## **ZONING CHANGE REVIEW SHEET**

CASE: C814-2014-0110.02.SH

ADDRESS: 7900 Loyola Lane  
Austin, Texas 78724

Project Name and Proposed Use: 7900 Loyola Lane. C814-2014-0110.02.SH. Project: Colony Park Sustainable Community Initiative PUD. A PUD amendment on 208 acres of land to update the Land Use Plan, permitted uses, maximum densities and site development regulations. Related item: Council Resolution # 20230608-053. Amend the Colony Park Plan to make it less prescriptive by: Restructuring the PUD to be more flexible and less prescriptive to better respond to unforeseen opportunities and changing market conditions and to adapt to the 2020 Land Use Plan. Reconfiguring the buffer areas and setbacks for the Critical Environmental Features (CEFs) to create a more cohesive and efficient land use plan. Reducing the number of street sections and bringing them into alignment with the Transportation Criteria Manual. Refining parking requirements to bring them into conformance with current market conditions. Adding Equitable Transit-Oriented Development. Making adjustments to the Open Space Plan, while maintaining a minimum of 41.63 acres (20% of the site) in parks and open spaces. Refin

# EXHIBIT C COLONY PARK P.U.D. LAND USE PLAN

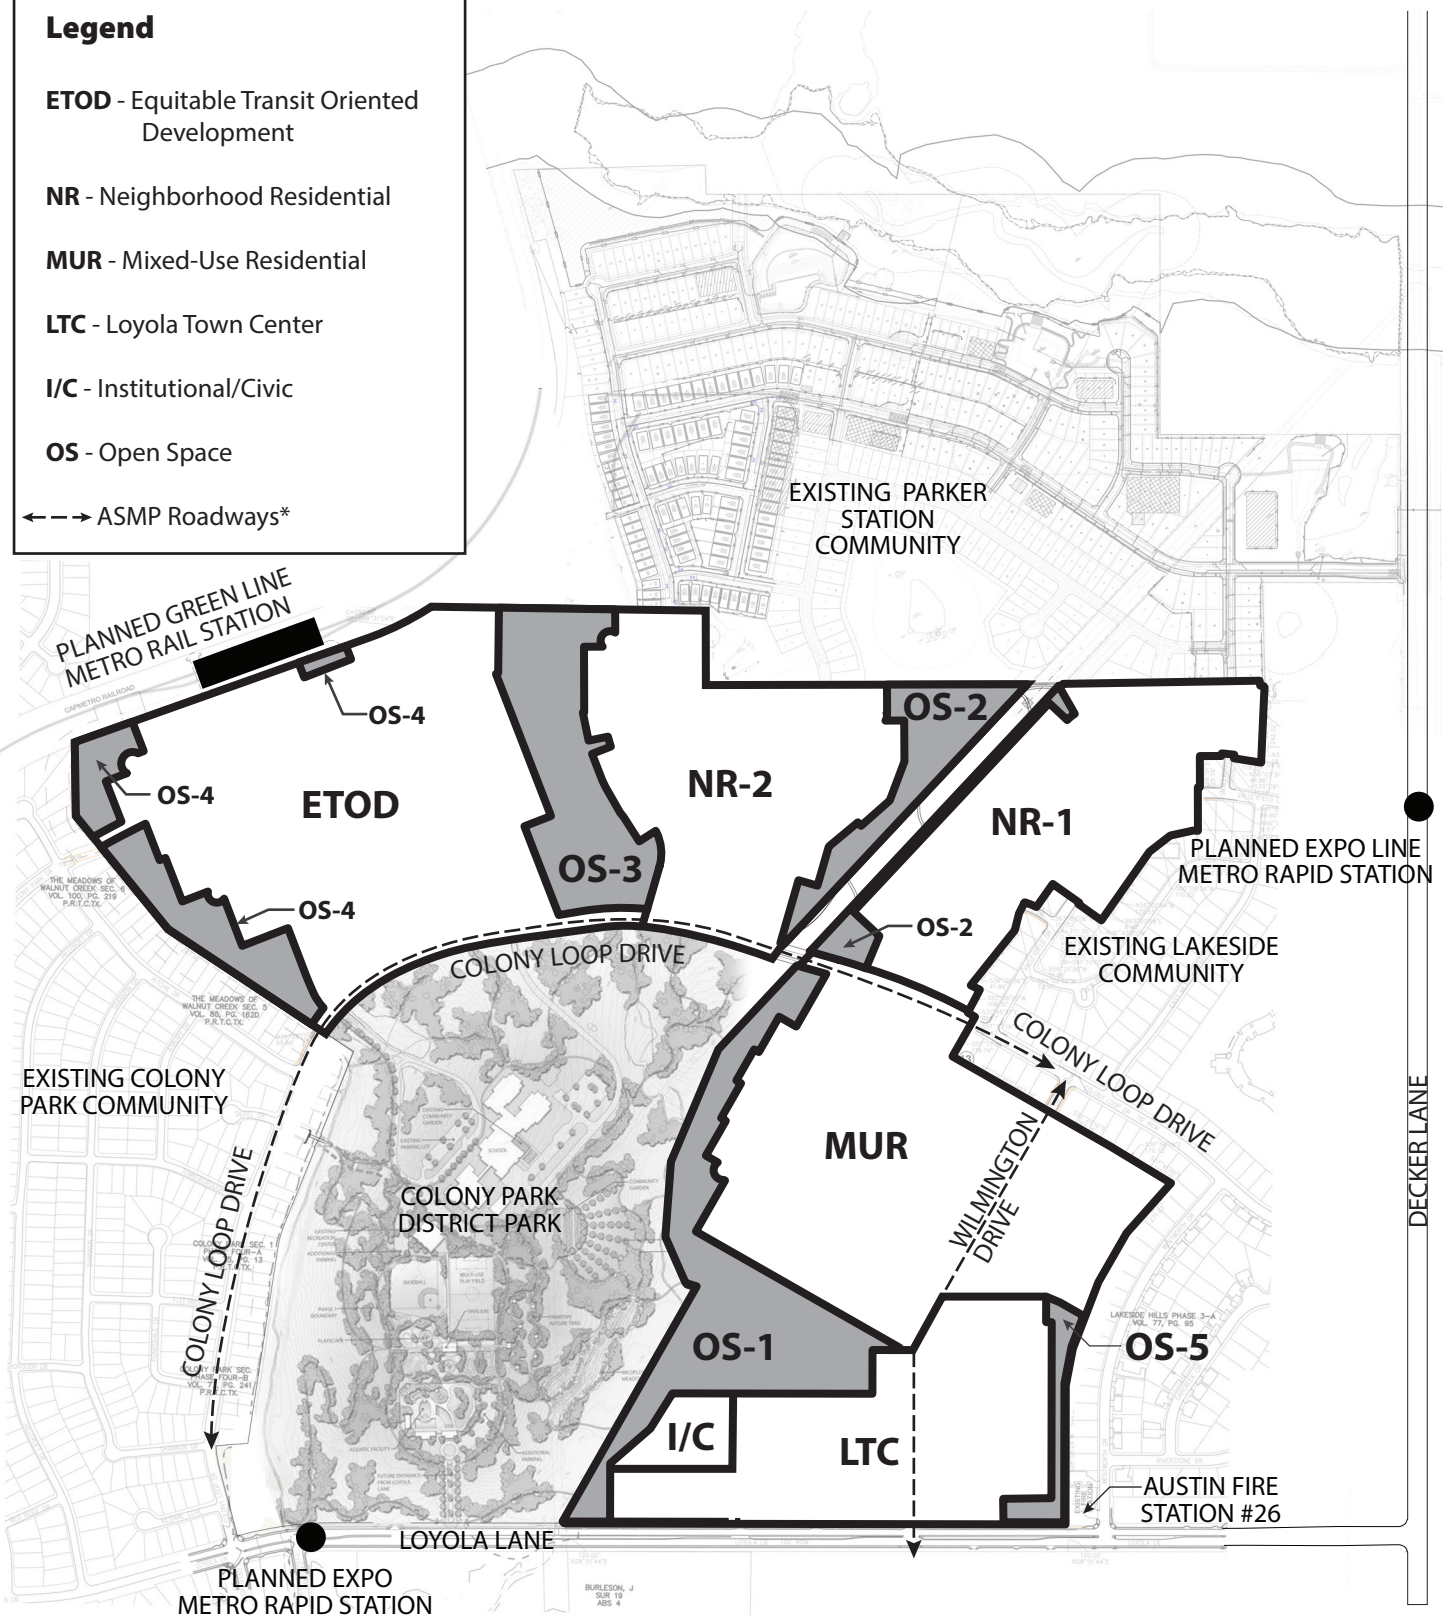
- ATD 7. Exhibit C should indicate roadways as required per the ASMP or suggest alternatives:
- Please indicate Colony Loop Drive, Wilmington Drive, Colony Park Dr-Valleyfield Dr Connector, Clearlight Trail, and Matthews Prairie Path.
  - A note specifying the exact alignment to be determined at time of subdivision may be added for flexibility.

**U1: Comment cleared.**

# EXHIBIT G (PAGE 1)

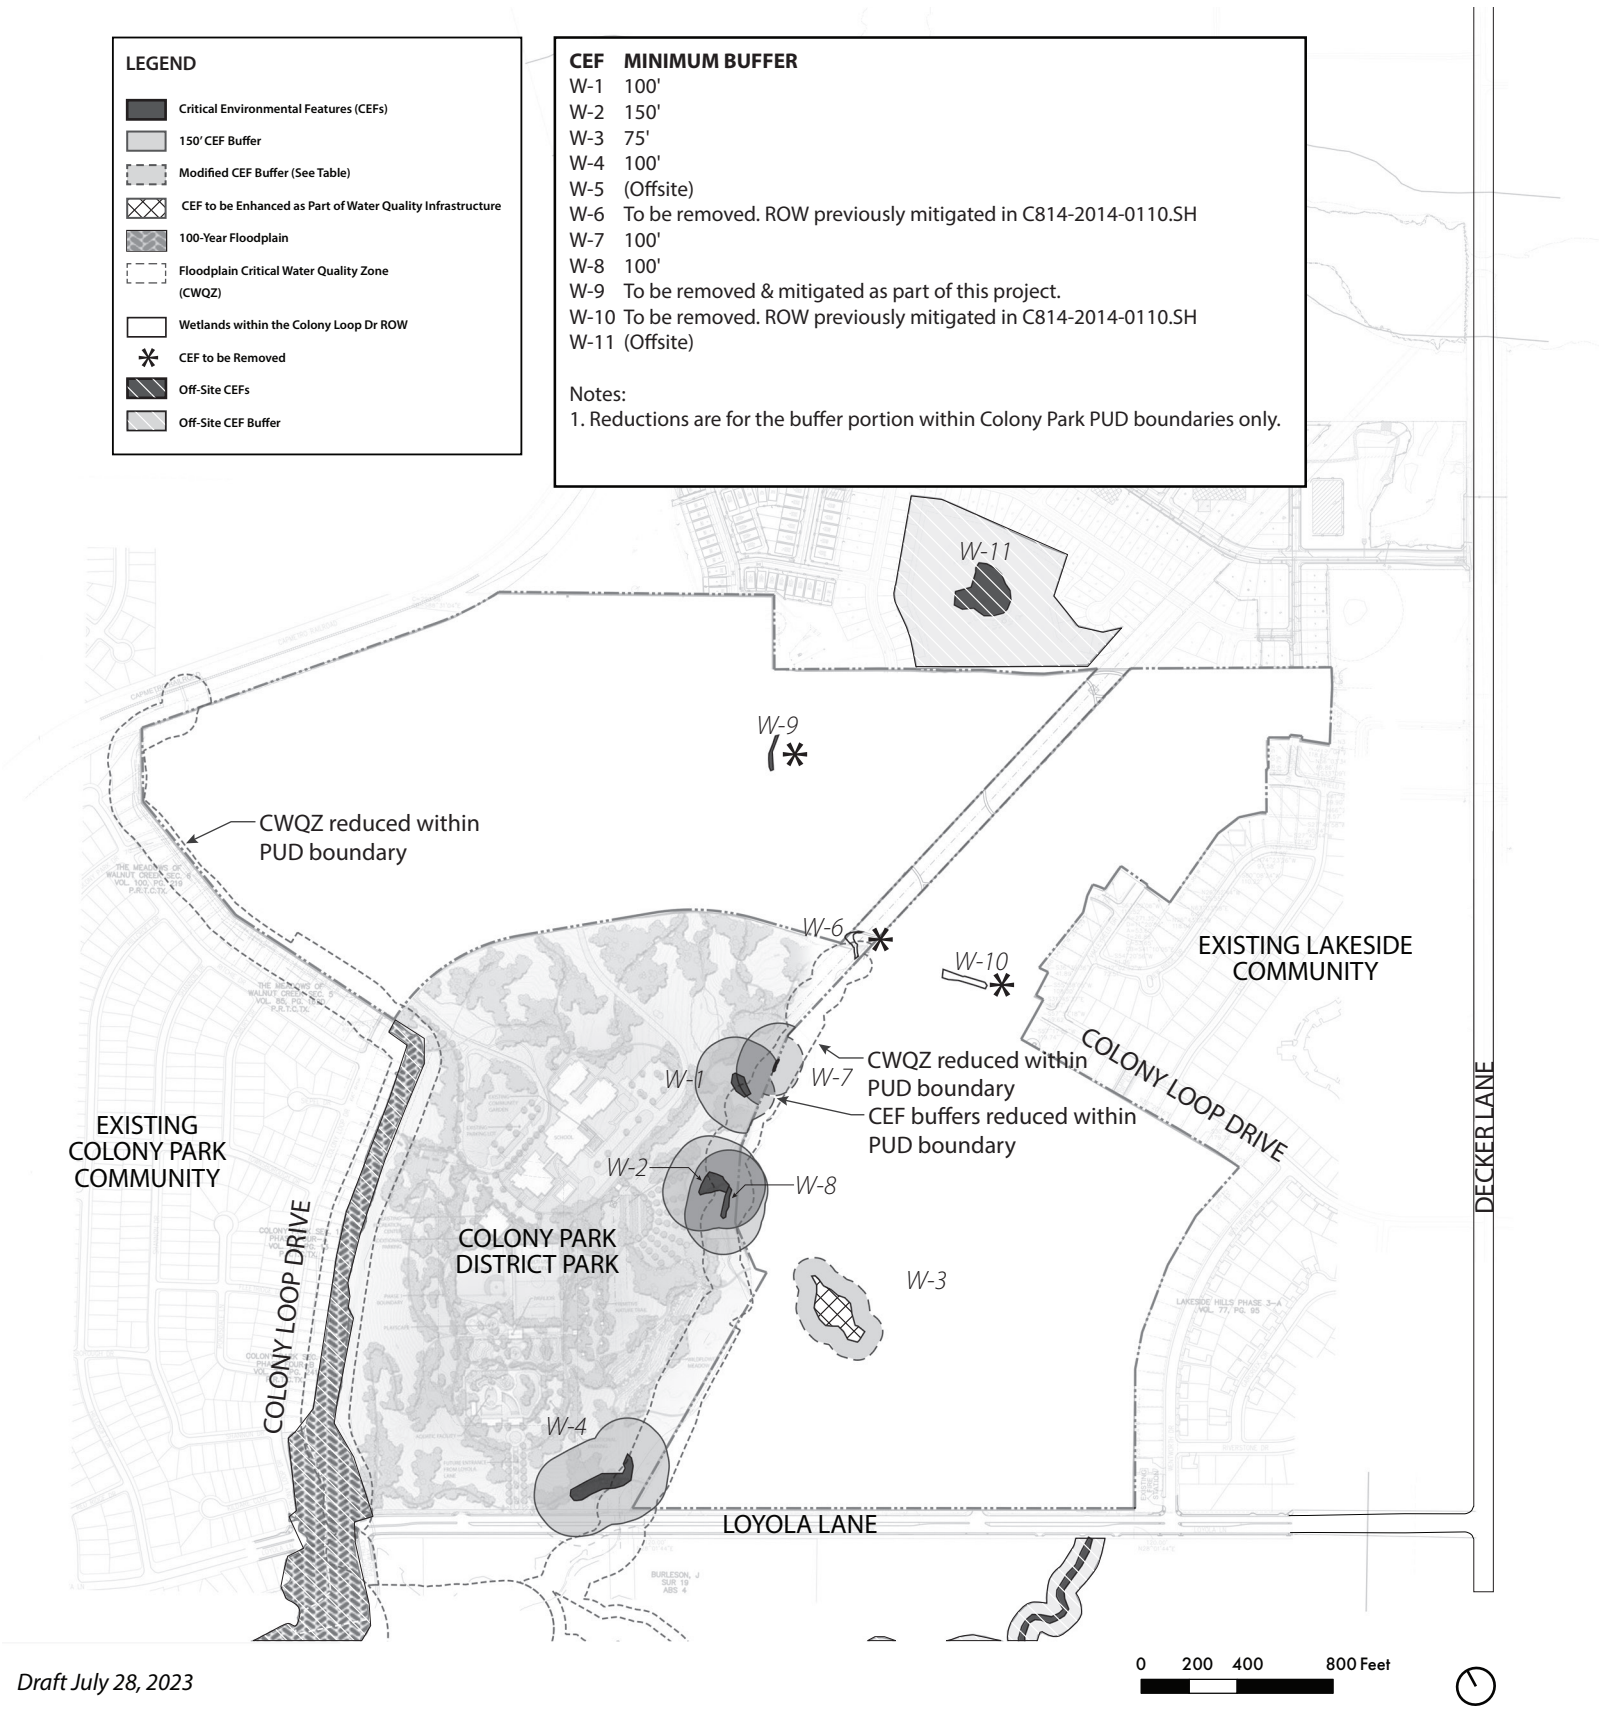
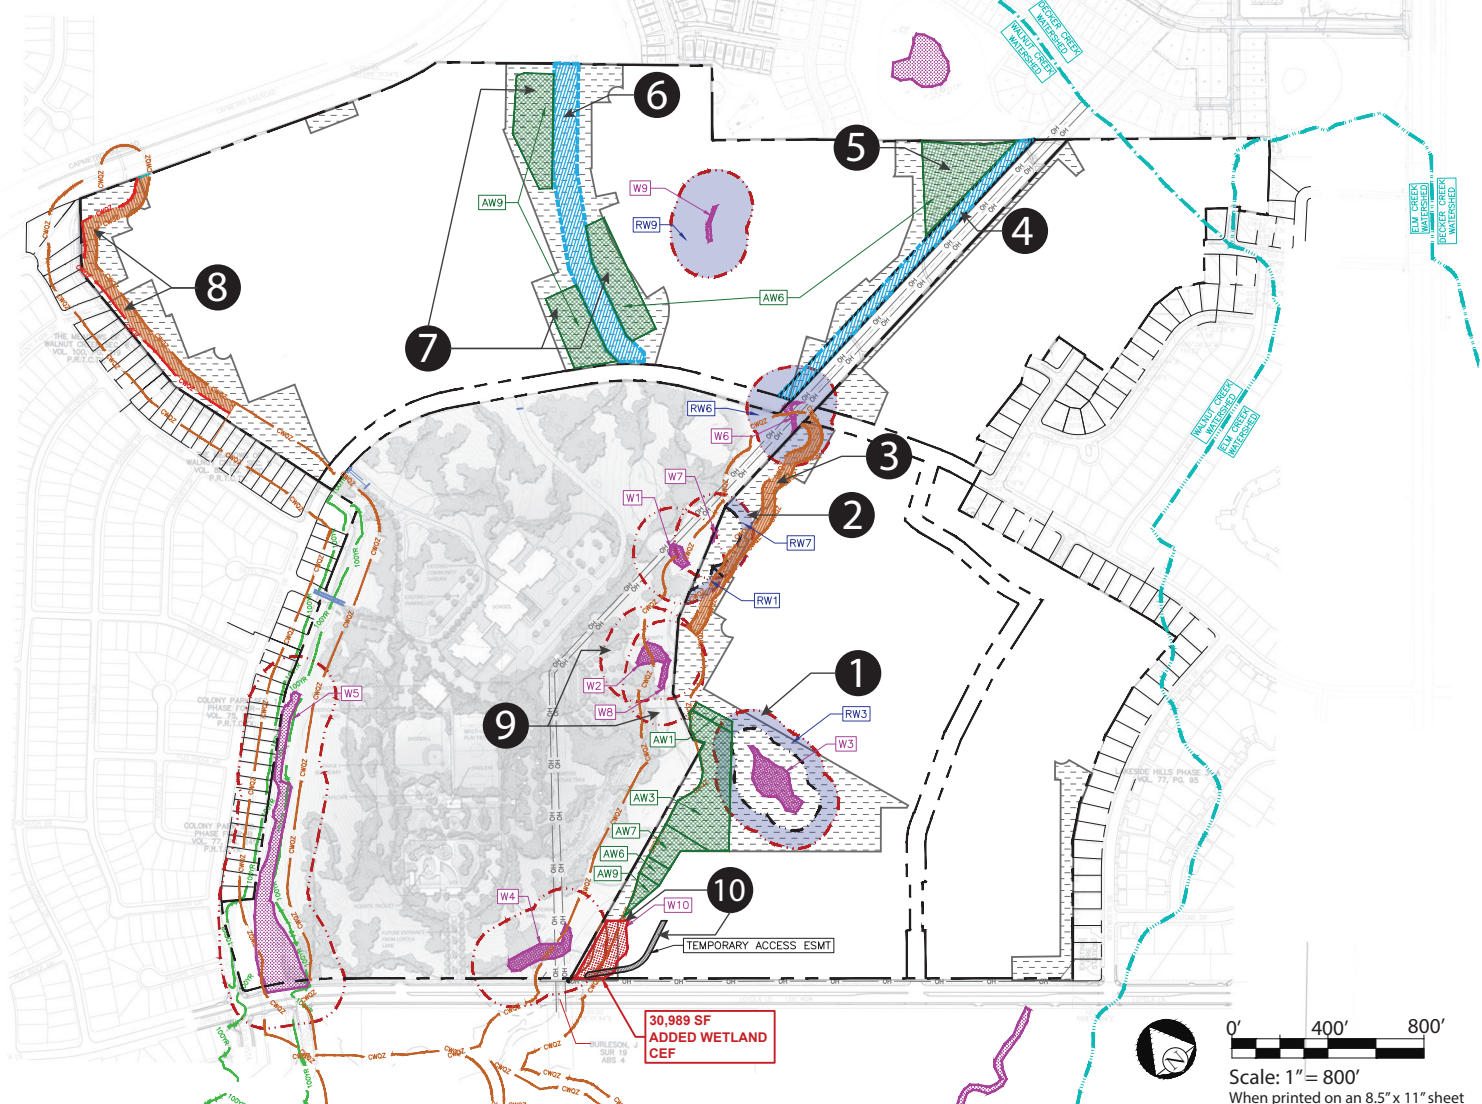
EV 16 Revise note #8, Exhibit G (page 3) as shown.

3. The CWQZ related to existing classified waterways has been modified as shown in Exhibit G. ~~and shall be exempt from all future CWQZ changes to currently unclassified waterways.~~ Additional protected headwater areas have been added. ~~These~~ mitigate for CWQZ reductions. (as shown in Exhibit G) ~~by providing protections for currently unclassified waterways. Additional protected headwaters shall not be subjected to CWQZ regulations. Additional protected headwater areas (designated in Exhibit G) are vegetated drainage conveyance areas draining less than 320-64 acres that promote healthy soils and vegetation along the creek corridor and allow the stream adequate space to migrate over time, thus controlling flood impacts, promoting water quality, and providing multiple community benefits. designated in Exhibit G established to enhance water quality.~~ Permitted activities and development in these areas ~~include~~ is limited to grading with revegetation, limited roadway crossings, trails and park amenities, utilities and utility crossings, and water quality facilities.

- “Grading with revegetation” sounds like a grass-lined channel. If this is the intention, it needs to be designed with WPD so that it mimics the features of a natural channel, including sinuosity and all the things listed in note #12, Exhibit G (page 3) – “...The restoration would at a minimum need to provide grade control structures that stabilize the channels and include the installation of check dams, cobble riffles, seepage berms, and in-stream installation of root wads and large woody debris.”

**WB6 Update 0.** The representation of removed/reduced/modified wetland CEFs and CEF buffers is difficult to track. Please adjust the symbology to clarify CEF/CEF setback areas removed and or added. Additionally, please add a table documenting the changes in area for each wetland CEF separately.

**Update 1.** Partially addressed. Include the following changes to the environmental Exhibit G

1. Distinguish between mitigation designated for the wetland CEF and the wetland CEF setback. The balance table should reflect the reduction and addition of CEF and CEF buffer in separate columns.
2. The wetland CEF mitigation should be added to the area spanning the CWQZ and the 500' elevation line (see below) . This area contains the undelineated mosaic wetland features described in the original WPD site analysis for the Colony Park PUD.

3. Please remove any extraneous line work from the exhibit unless it indicates a reduction or addition of area (see example below showing red X's).

**COLONY PARK P.U.D. OPEN SPACE PLAN**

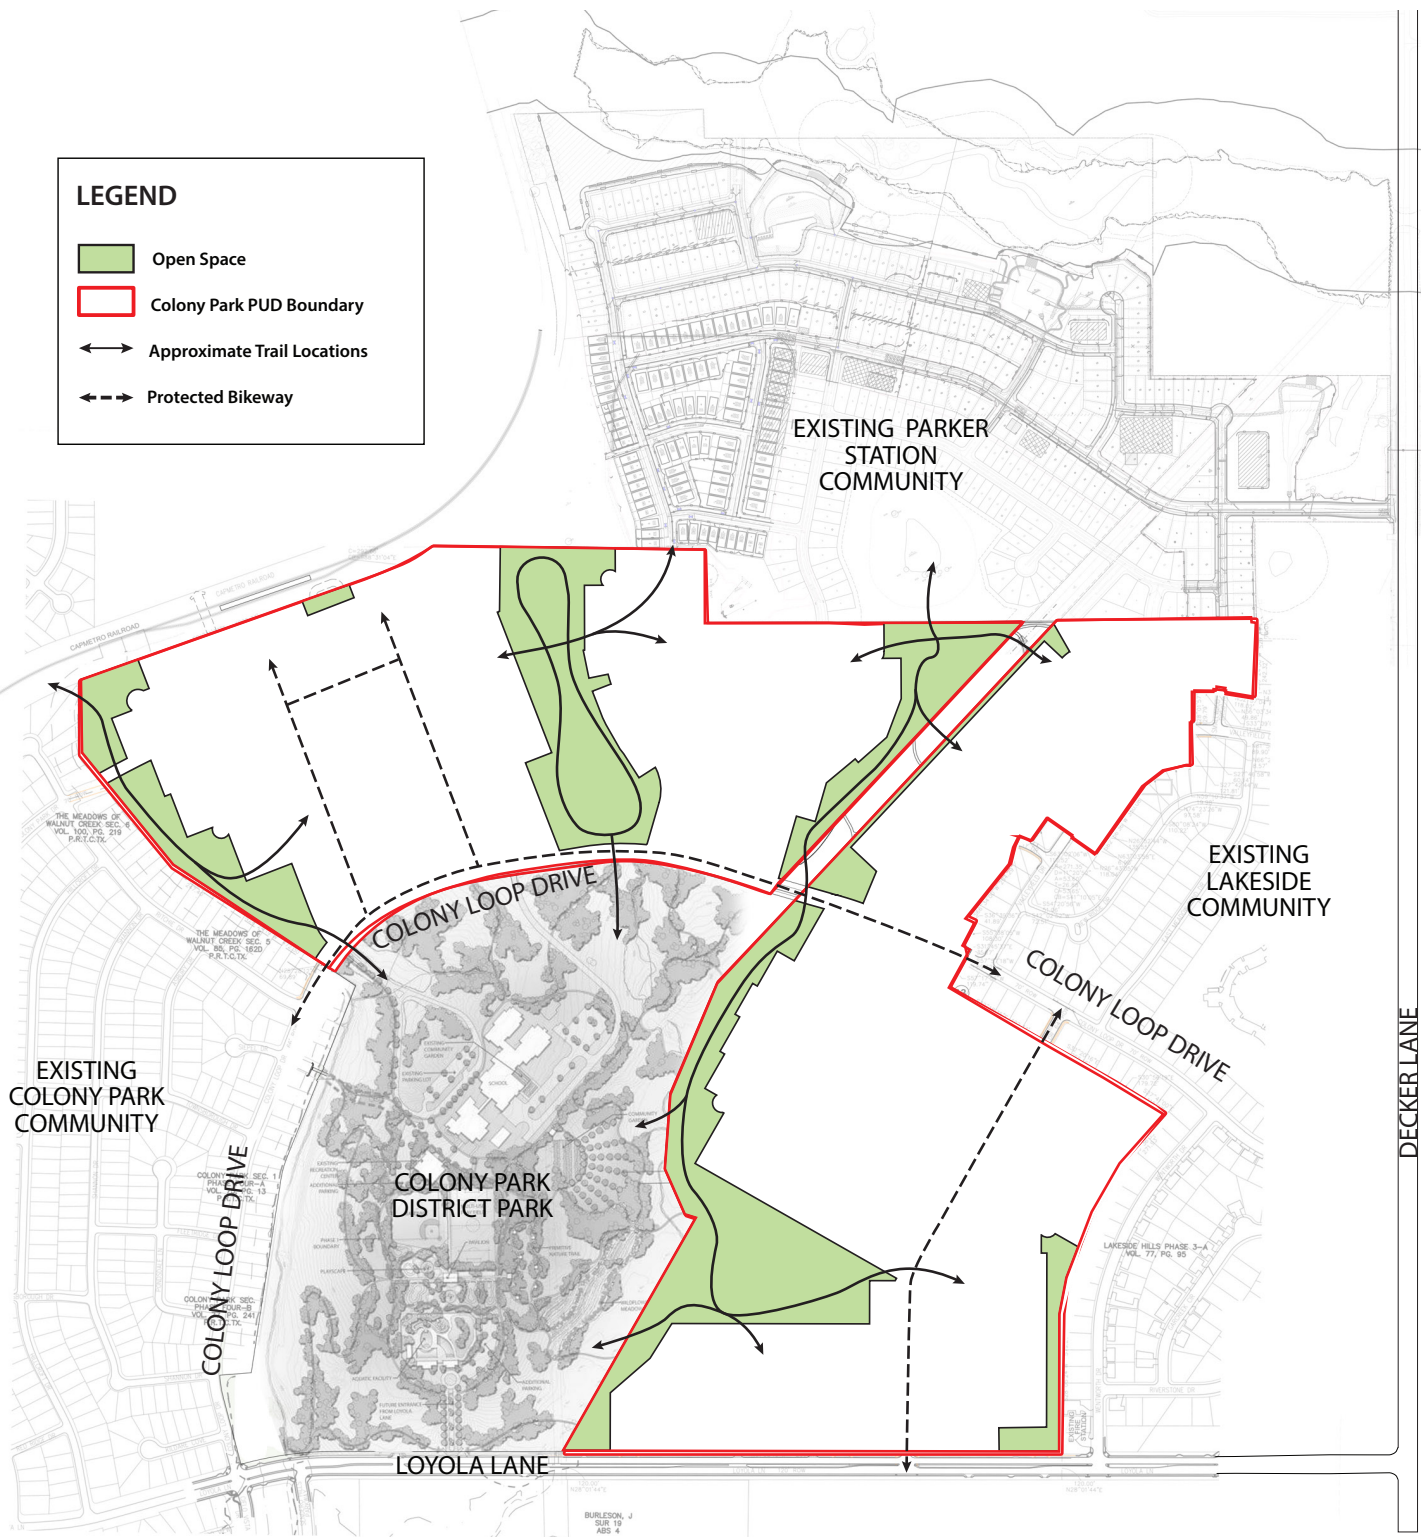
PR2: Trail and recreational amenities must be allowed within the designated open space areas. Given that large areas of the open space fall within CEFs/CEF buffers and CWQZs, please note on the open space plan that any required trails and recreational amenities are allowed within those areas. Revise Part 6, #3 of the original ordinance in such a way that improved surface trails and other recreational amenities are allowed within the entire Open Space areas with PARD approval.

U1: Note explicitly on the parks and open space plan, environmental exhibits, and in code modifications that the parks amenities contemplated are allowed by right within the open space areas, with the exception of the wetland identified by the environmental reviewer in the southern portion of OS-1, south of the convergence of the creeks; divide OS-1 into two OS areas, OS-1 and OS-1.1 (for the southern area just noted along the Central Health site), and denote restrictions to amenities within OS-1.1.

## Colony Loop Drive

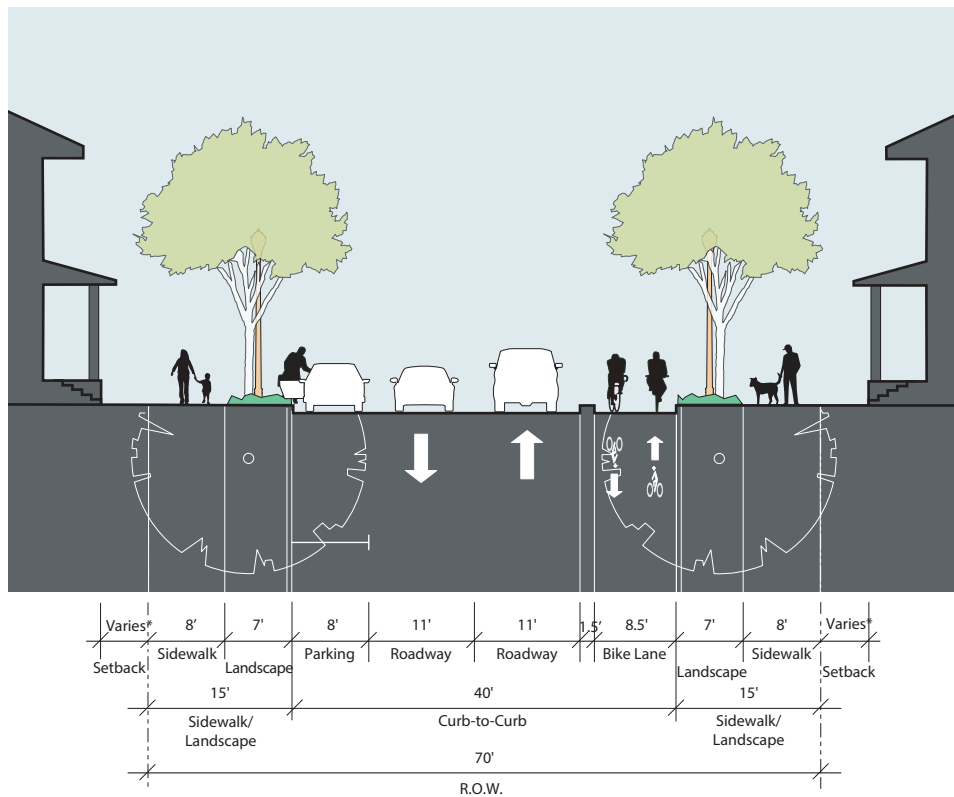
**U2: Comment cleared. Please note the discrepancy between the 70' ROW identified under Exhibit I (pg. 28) and a 72' Colony Loop Drive cross section shown Exhibit I (pg. 30). ATD recommends the 72' ROW, consistent with the ASMP, and revising bike facility to the TCM recommended 10' minimum, which the applicant had previously agreed to.**
